Technical product information

Topic	Bentayga Front brake squeal - 1.5 KHz to 2.0 KHz
Market area	Australia E04 Bentley rest Asia and Australia (6E04),China 723 Volkswagen (Anhui) Automotive CO (6723),China 796 VW Import Comp. Ltd (Vico), Beijing (6796),Germany E02 Bentley rest Europe (6E02),Japan E03 Bentley Japan (6E03),Korea, (South) E08 Bentley South Korea (6E08),United Arab Emirates E06 Bentley Middle East and Africa (6E06),United Kingdom E01 Bentley UK (6E01),United States E05 Bentley USA and rest America (6E05)
Brand	Bentley
Transaction No.	2054862/10
Level	EH
Status	Approval
Release date

Front brake squeal with a frequency of 1.5 KHz to 2.0 KHz

Figure 1

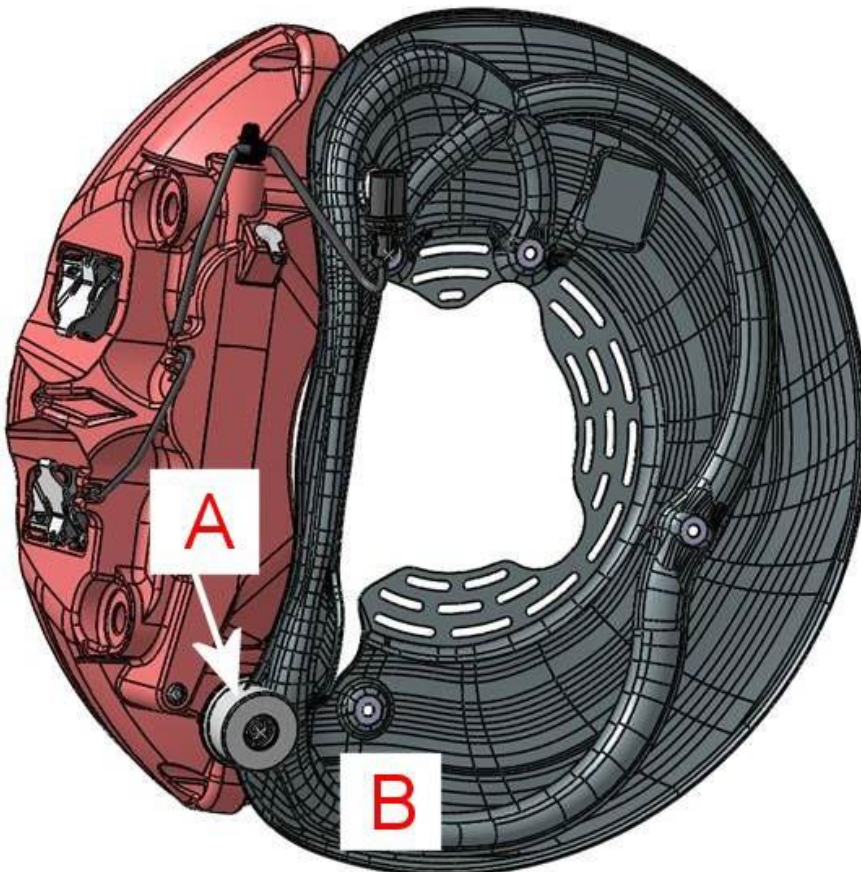
Referring to Figure 1, the replacement front callipers have a Dynamic absorber fitted (A), the brake disc guard plates (B) are pre modified to fit around the absorber

Modified front brake Callipers and modified front brake disc guard plates are available on receipt of a qualifying DISS query

Figure 2

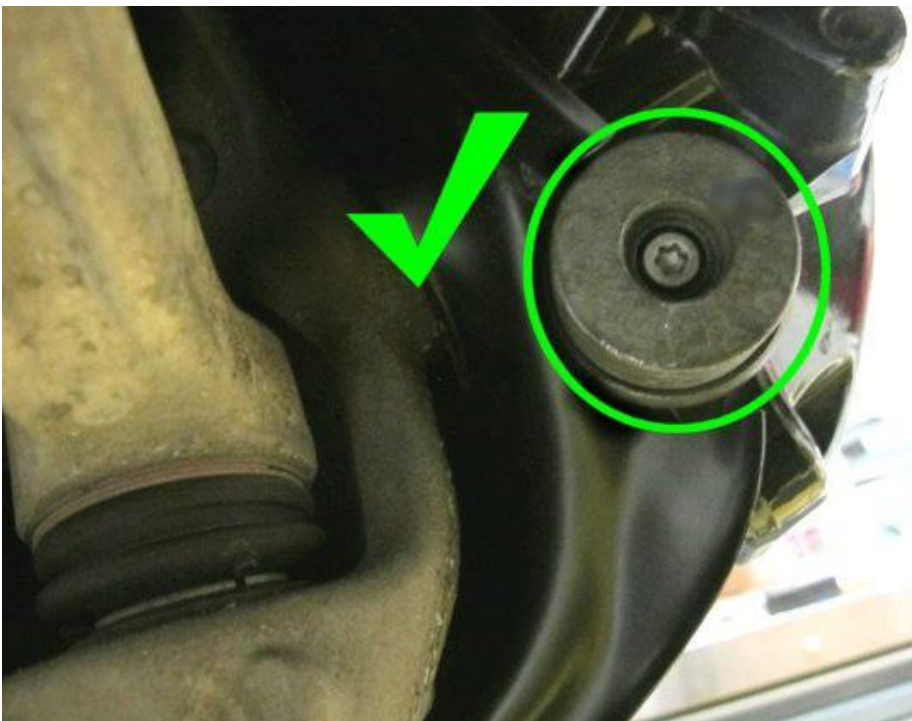
- Fit both front brake discs - Refer to Repair manual Rep.Gr 46
- Fit the replacement front brake callipers and brake pads - Refer to Repair manual Rep.Gr 47
- Referring to Figure 2, once fitted check and confirm the disc guard plates are not touching the brake calliper Dynamic absorber
